# ***Interactive comment on “Hydrological control of large hurricane-induced lahars: evidences from rainfall, seismic and video monitoring” by Lucia Capra et al.***

Response to RC2.

Figure R1. Comparison of simulated watershed discharge curves based on SCS-NC and G-A infiltration models. Qualitative calibration is here proposed based on the flow discharge as observed at the MSL site.

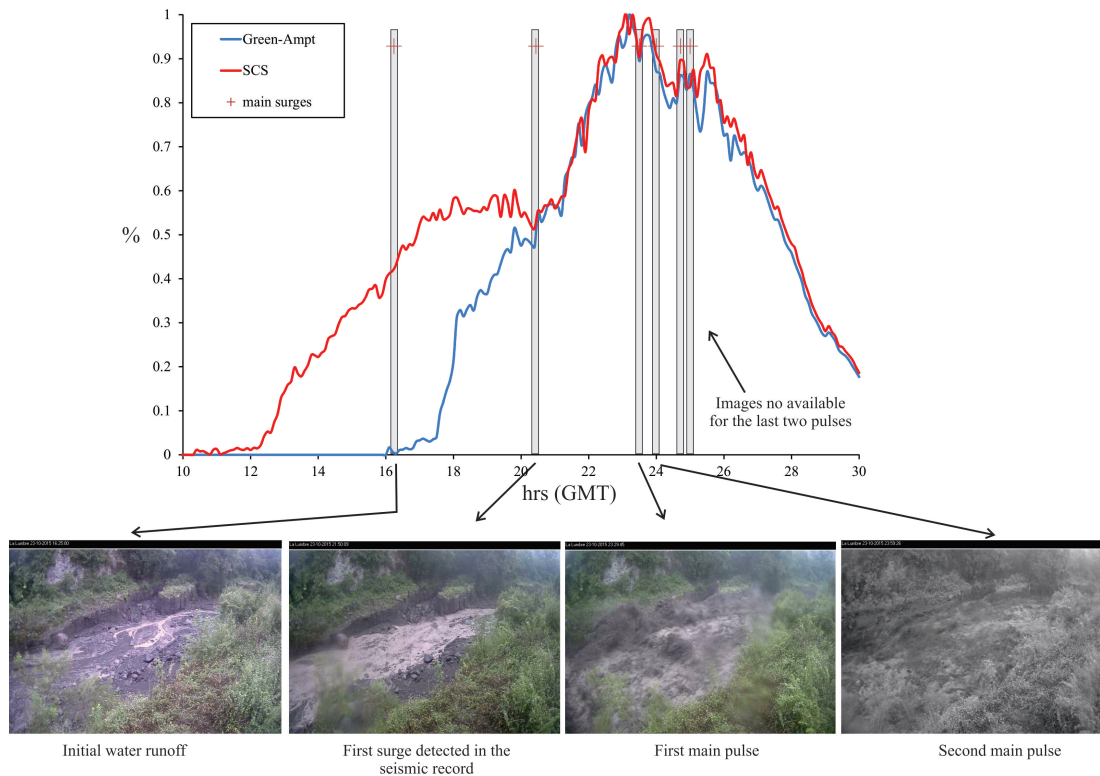
1. What are the assumptions of the SCS curve model and how may it affect results? The SCS approach is a simplified method for estimating rainfall runoff. Lower curve numbers result in less runoff for the same amount of rainfall. However, as stated on lines 229-231, this model simplifies the complex relationship between rainfall and overland flow into a single number. A weakness of this approach is that the curve number does not consider the effects of single storm properties (e.g. rainfall intensity) on infiltration.

R1: We agree with the reviewer that SCS-NC method does not consider the effect of the rainfall intensity on infiltration, a key point for the cases here analyzed. But it is worth mentioning that here the rainfall input for the FLO-2D simulation is given as a non-linear hydrograph curve where accumulated rainfall is discretized at each 10 minutes interval (as detected with the raingauge). Based also on the comment by L. Marchi (SC1), we tested the Green-Ampt (G-A) rainfall-infiltration method and we calibrated it with the images available for the Patricia event along the La Lumbre ravine, at least for the arrival time of the first slurry flow and for the main surges (this last correlation was already presented in fig.8). The parameters used for the Green-Ampt method were selected from FLO-2D reference tables according to the textural characteristics of the soil on the watershed (Table R1). The Ks (saturated hydraulic conductivity) of 20 mm/hr gives the best fit, and based on the equation proposed by Chong and Teng (1986) it corresponds to a CN of 75.5 in the range of the value used for the simulation performed with the SCS-NC method (see detailed explanation in the text below). It is worth to mention that the input parameters here used for the G-A model represent an average value for the entire watershed.

Figure R1 (see below) shows the comparison of the discharge curve obtained with the SCS and G-A methods and their comparison with selected images of the flow along the La Lumbre channel during the Patricia event. One first issue is the coincidence of the first water runoff along the channel observed in the image with the rise of the discharge in the curve modeled with G-A method, as the SCS-CN is not able to re-

produce it. In fact, we performed additional simulation to try to reproduce the initial slurry flow with the SCS method but it was impossible. This can be explained considering that the model automatically assumes an initial abstraction (rainfall intercepted by vegetation) of  $0.2S$ , where  $S$  is the potential retention included in the CN calculation ( $CN=2540/(S+25.4)$ ) (Mockus, 1972), value that it is too high for the studied area. In contrast, the value of initial abstraction can be controlled performing the simulations with the G-A method. However, the main peak discharges corresponding with the main lahar pulses are equally reproduced with both models. Under this evidence, we are able to affirm that the G-A method is much more reliable to detect the first stream-flow, but the SCS method is also able to catch the main surges. One important point is that the simulations are here used to set up an early warning system to forecast the lag time of main lahar pulses at a specific site. The first water runoff along the channel was fundamental to calibrate the G-A simulation but it is not an essential data for the early warning system. In addition, input data for the G-A method are probably much more difficult to set, in contrast to the SCS method where only one parameter is needed. A new section has been added within the paragraph “2.4. Rainfall-runoff modeling” to show the comparison between the two infiltration methods based on which the SCS model was selected to be used in the early warning system. The SCS method has been largely used in rainfall-runoff estimations, and we consider that is a valuable method for the objective of the present work. This section was modified as follow:

the saturated hydraulic conductivity ( $K_s$ ), the soil suction and the volumetric moisture deficiency.  $K_s$  is the key factor in the estimation of infiltration rates and exerts a notable influence on runoff calculations, therefore it requires great care in its measurement (Grimaldi et al., 2013). These values can be extrapolated from reference tables or directly measured with field experiments. Based on the textural characteristics of soils at Volcán de Colima as well as type of vegetation, input parameters were selected from the FLO-2D reference manual. In particular, with a value of  $K_s$  of 20 mm/hr the simulated watershed discharge best fits with the precursory shallow-water flow observed in the video images, as it will be showed below (Figure R1). The  $K_s$  value of 20 mm/hr is equivalent to the CN value used for the SCS-NC simulation. In fact an empirical relation between  $K_s$  and CN has been proposed by Chong and Teng (1986):  $S = 3.579K_s^{1.208}$  where  $S$  is the potential retention and it is related to the CN as follow (Mockus, 1972):  $CN = 2540 / (S + 25.4)$  Based on these equations, a value of  $K_s$  equal to 20 mm/hr corresponds to a CN of 75.5 in the range of values here used for the SCS-NC infiltration model. The G-A infiltration model was tested at La Lumbre ravine, using the Patricia rainfall and comparing the simulated watershed discharge curve with the available video images. Figure R1 shows the discharge curve that best fits with the data gathered from the images, based on which the two methods were qualitatively calibrated. The G-A infiltration model nicely reproduces the initial scouring of a muddy water and it corresponds with the first increase in the simulated watershed discharge. The SCS-CN infiltration model is not able to reproduce this first water runoff. This can be explained considering that the initial abstraction due to the interception, infiltration and surface storage, is automatically computed in the SCS-NC model as  $0.2S$ , being probably too high for the studied area. In contrast, with the G-A method, the initial abstraction can be modified and best results were obtained with a value of 6 mm that corresponds to a surface typical of a vegetated mountain region. However, both infiltration models give similar results for the main peaks of the simulated maximum watershed discharge that correspond with the arrival of the main lahar pulses as observed from the image (Figure R1). These results show that the G-A model is much more reliable to detect

precursory slurry flows, while both models are equally able to catch the main surges of a lahar. One important point is that the simulations are here used to set up an early warning system to forecast the lag time of the main lahar surges. The first slurry flows were here important to calibrate the G-A simulation but they do not represent an essential data for the early warning system. In addition, input data for the G-A method often are difficult to set, requiring great care in its measurement; in contrast, the output of the SCS-CN method only depends on the CN value. The SCS-CN method has been largely used in rainfall-runoff modeling, and we consider that is a valuable method for the objective of the present work, as we are not seeking for a quantitative estimation of the watershed discharge but on the arrival time of the main lahar pulses.

Fig. R2. Normalized rainfall of the Jova and Patricia event as gathered form different stations, pointing to a quasi-stationary rainfall behavior.

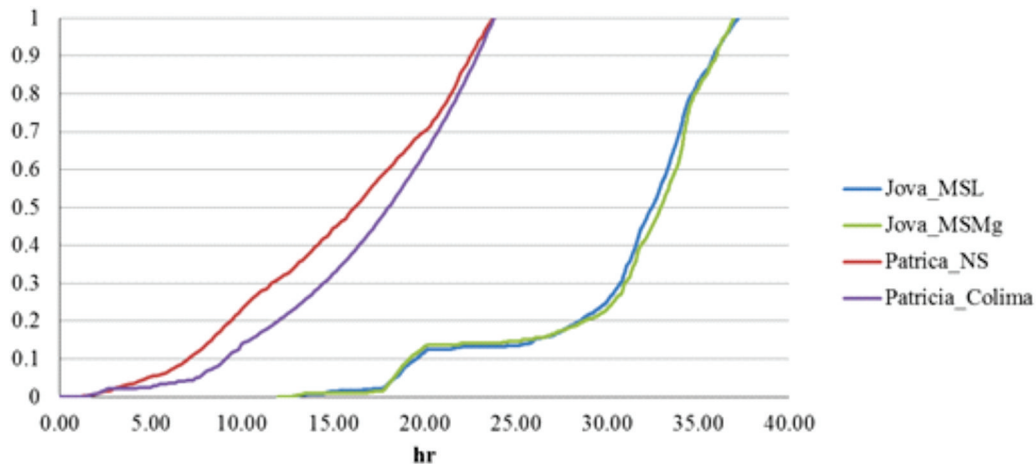
2. How was rainfall applied over the simulation domain? The authors state that the rainfall 10 minute intervals were applied to the simulation (lines 249-50). However, there is no indication if this varied spatially. If a spatially homogeneous rainfall input was used, the authors need to indicate this and, in discussion, consider the effect of this assumption on results and implication for the migratory, long duration rainfall scenarios.

R2: The rainfall was applied to the entire watershed, no spatial variation was assumed. As stated before, the total amount of accumulated rainfall is discretized in 10 minutes interval, introduced in the code as a no-linear hydrograph. During tropical rainfalls rains are nearly stationary on top of the volcano. This can be observed by comparing rainfall data from different stations (fig R2). This figure will be added as extra panel in figure 3.

**Fig. 4.** Figure 8 modified

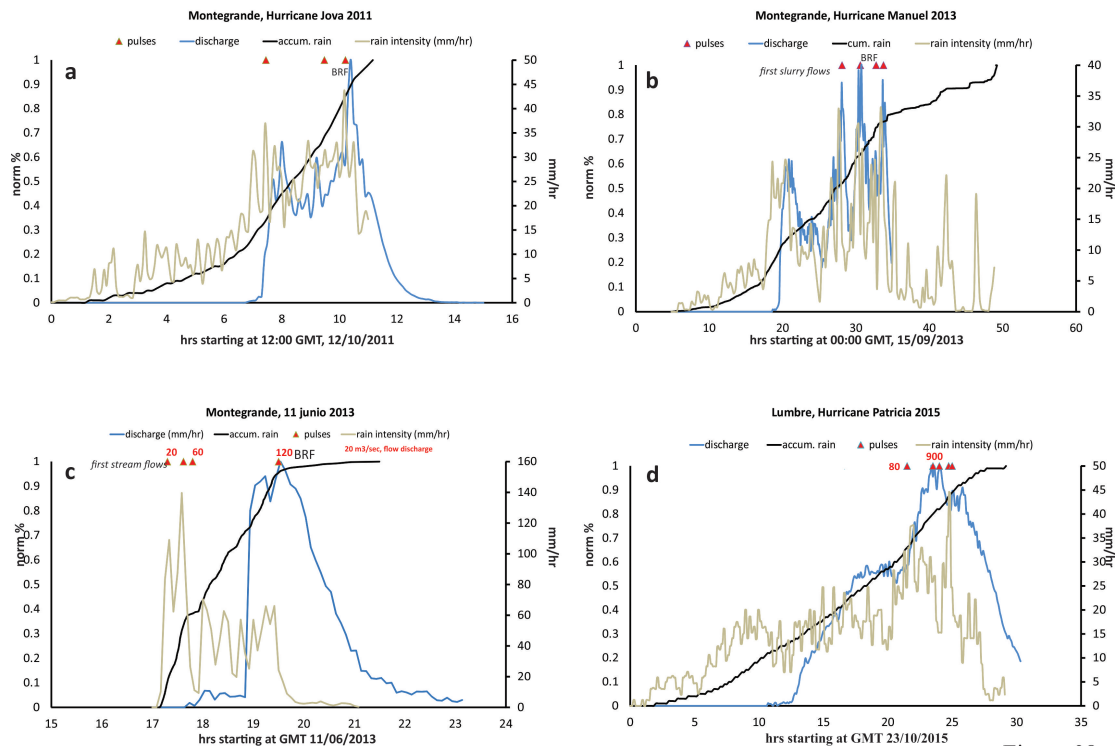
3. Related to point 1, in Fig. 8, simulated discharge shows better correlation to identified lahar pulses during Hurricanes Jova, Manuel and Patricia. In these events, rainfall intensity is much lower and cumulative rainfall is more linear than the 11 June event. This highlights a potential limitation of the runoff erosion model that needs to be identified and discussed.

Line 338-340: "Nevertheless ...", in Fig. 8c, only one of the four observed pulses coincide with the simulated discharge - this correlation could be (in my opinion likely is) pure coincidence for this event - you need to account for this. I would recommend removing this sentence entirely, as it is largely repeated in lines 357-359.

Fig. 8 needs to be improved, suggest the following: In the caption, rain intensity is a gray line, but in the figure it is gold/yellow. Fig. 8b - "Rain" and "Rain intensity" legend entries are switched Left axis (%norm) should only be between 0 and 1 (see above) Arrows in Fig. 8c do not seem to indicate anything - should "first stream flows" text be placed nearby? Color and line choice makes it hard to discriminate between rain intensity and discharge. Try adjust colors or line thicknesses.

R3: The 11 June 2013 event is presented to stress the fact that at the beginning of

the rains season no-stationary, orographic events trigger lahars after few minutes of accumulated rainfall ( $\sim 10$  mm); in those cases, main pulses are clearly controlled by rainfall peak intensities, mainly because of a strong hydrophobic effect of the soils (see Capra et al., 2010). Therefore, the model here presented does not work for such type of events and can be only used during tropical rains associated to hurricanes, with low rainfall intensities and long durations. This concept is clearly stated in the discussion:

-As stated into the test the 11 June 2013 event does not fit with the model here proposed, but apparently only the last largest pulse correspond with the simulated watershed discharge.

Figure was improved as suggested (see next page)
